**Port Kembla Gas Terminal — Modification 1  
Response to request for additional information**

The table below provides responses to the requests for additional information from the Department of Planning, Industry and Environment; Environment Protection Authority (DOC20/115960-2), and the Department of Primary Industries — Fisheries (C20/99 and C19/696).

Figure 1 Risk contours (EIS base case)<sup>1</sup>

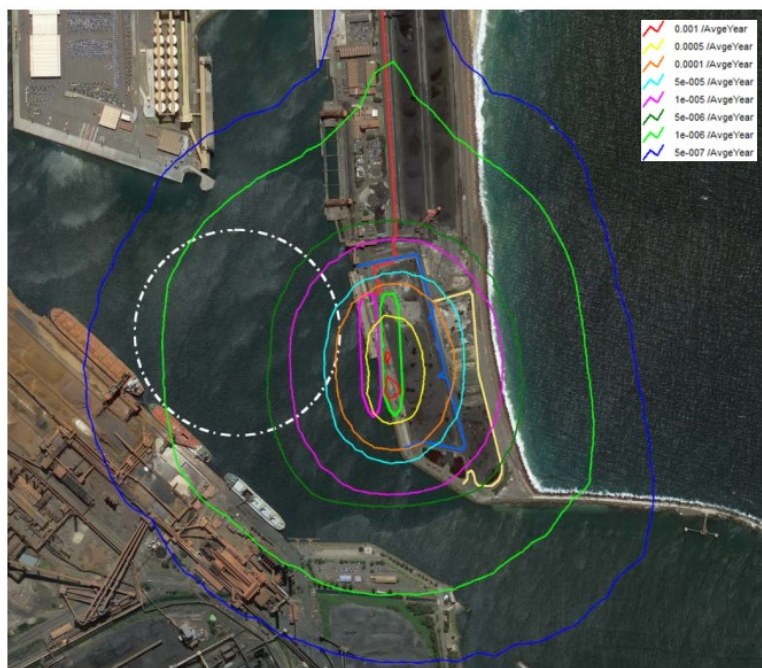
Issue	Response																														
<p><u>Base case risk contours</u></p> <p>The submission makes reference to the preliminary hazard analysis of the proposed modification.</p> <p>It states that the risk contours in the preliminary hazard analysis of the proposed modification are smaller than the risk contours in the environmental impact statement.</p> <p>It requests clarification on the assumptions for each modelled scenario and a comparison of the risk contours in the proposed modification and the environmental impact statement.</p>	<p>The assumptions for each modelled scenario in the preliminary hazard analysis of the proposed modification are summarised below. It should be noted that the preliminary hazard analysis of the proposed modification also includes a refined location of the regasification unit within the FSRU based on refined design information placing it about 37 metres from the front of the vessel, compared to 46 metres from the front of the vessel in the EIS.</p>

Issue	Response
	<p>The risk contours for the EIS base case and modification base case are shown for comparison in Figure 1 and Figure 2. As shown, there is some increase in the outer risk contours to the west and the south-east from the EIS base case to the modification base case, which is attributable to the increase in assumed shipments per year from 26 per year in the EIS base case to 52 per year in the modification base case. The inner risk contours have not materially changed in extent but have moved slightly to the south as a result of the refined location of the regasification unit in the preliminary hazard analysis of the proposed modification discussed above. Further, risk contours for the low season (Figure 3) were considerably reduced compared to the modification base case while risk contours for high season sensitivity analysis (see Figure 5) were similar to the modification base case.</p> <p>As discussed in the proposed modification hazard and risk assessment, the proposed modification would not introduce additional hazardous inventories or scenarios. Consistent with the findings of the EIS, the assessment found criteria for sensitive areas, residential areas and commercial development would be met in all cases, as would the criteria for injury and propagation. Limited risks to open space and industrial areas have been identified which, consistent with the risks identified in the EIS, would include a section of Seawall Road and the small offsite area west of the truck washing facility associated with the coal terminal adjacent to Berth 101.</p>

**FSRU cross section showing location of seawater intakes**

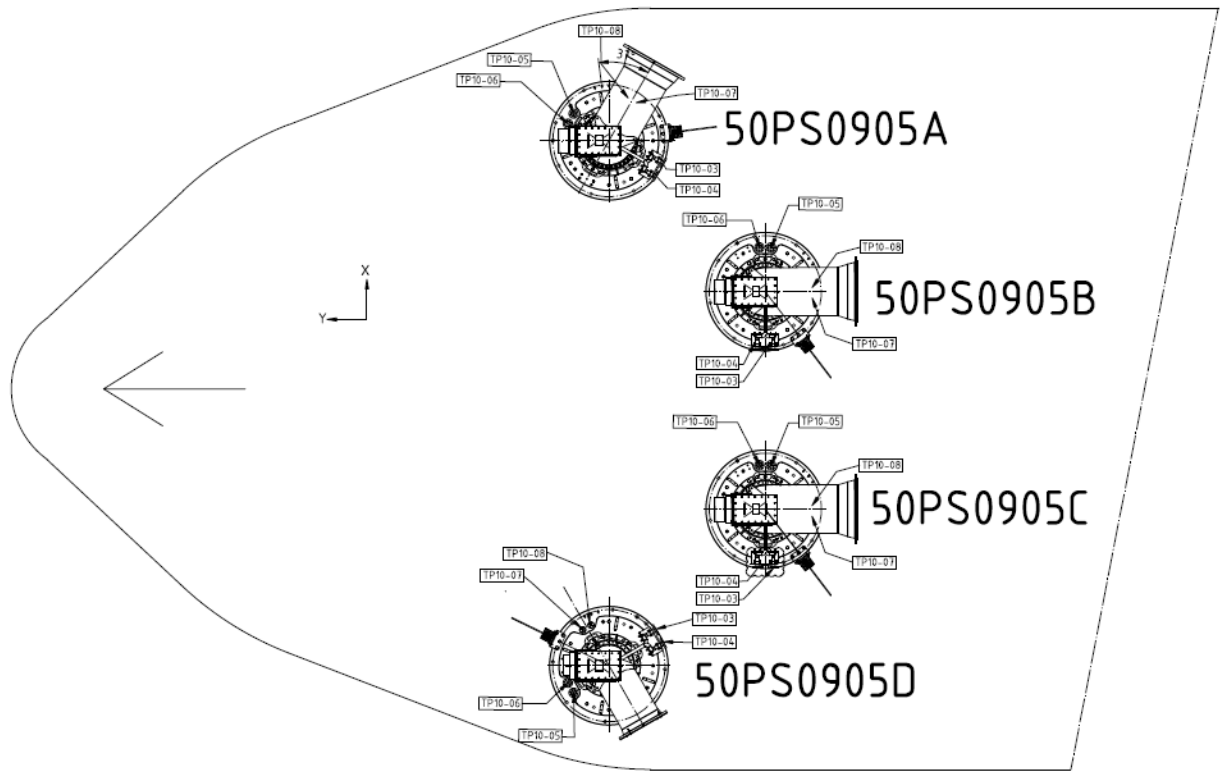
<p><u>Design of intake structure</u></p> <p>The submission requests Department of Primary Industries Fisheries be consulted concerning the design of the water intake structure.</p>	<p>Design information for the water intake structures and strainers is provided in Attachment A.</p>

Issue	Response
	<p>The water intake structures would have an opening of about 2.3 m<sup>2</sup>, noting the installation of the above meshed strainers, and would be situated at a depth of about 13 m beneath the surface while the vessel is fully loaded.</p> <p>The water intake velocities at the openings of the strainers would vary between about 0.39 m/s in the low season and 0.785 m/s in the high season.</p> <p>It should be noted that these velocities supersede those described in earlier responses to submissions which indicated that the maximum intake velocity during high season operations was greater than 0.785 m/s. Since that time, additional information provided by the vessel manufacturer has confirmed that the maximum high season intake velocity is based on the maximum flow capacity of each seawater intake. This means that when the maximum flow capacity of one of the seawater intakes is reached, the FSRU begins using additional seawater intakes, which ensures the intake velocity remains at or below 0.785 m/s at all times.</p> <p>The Inner Harbour is highly developed and subject to ongoing disturbance from various industrial and port activities. The existing marine habitat is limited to hard and soft substrates with biofouling community structures that are reflective of a highly disturbed environment. The fish assemblages understood to be present are common across the region and do not include threatened species.</p> <p>As noted in the EIS, the Inner Harbour in particular is not known to support as many species as the Outer Harbour. Potential impacts on fish species present would be further limited due to the depth of the intake and the tendency for fish species to inhabit shallower parts of the water column due to the availability of light and food.</p>
